Product Change Notification Number: F02/2011

Title: Carrier tape material change in multilayers 0805 size

Dimensions of blister tape

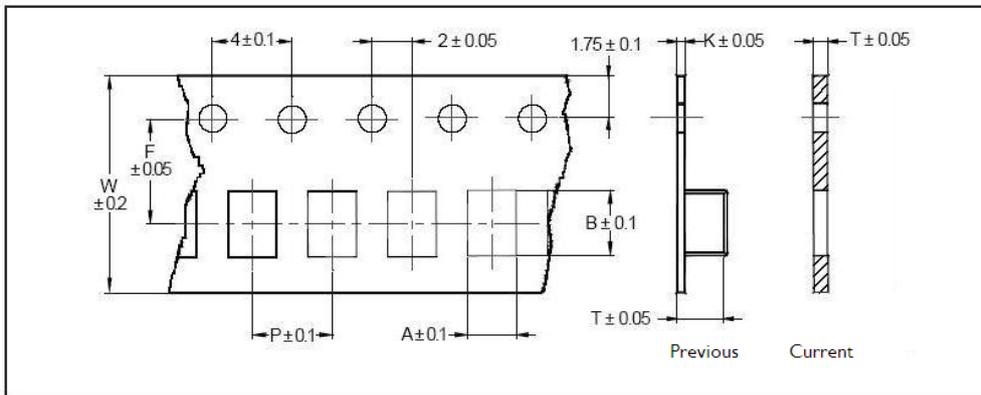
Change Description: All 0805 multilayers supplied by Ferroxcube will be packaged in paper carrier tape instead of polystyrene carrier tape. Affected dimensions on blister tape compared to old dimensions are shown below:

Previous dimensions (in mm)

Type	A	B	T	W	P	F	K
MLI, MLN, MLP, MLS, MLH	1.42	2.25	0.22	8	4	3.5	1.04

Current dimensions (in mm)

Type	A	B	T	W	P	F
MLI, MLN, MLP, MLS	1.5	2.3	0.97	8	4	3.5
MLH	1.58	2.42	0.95	8	4	3.5
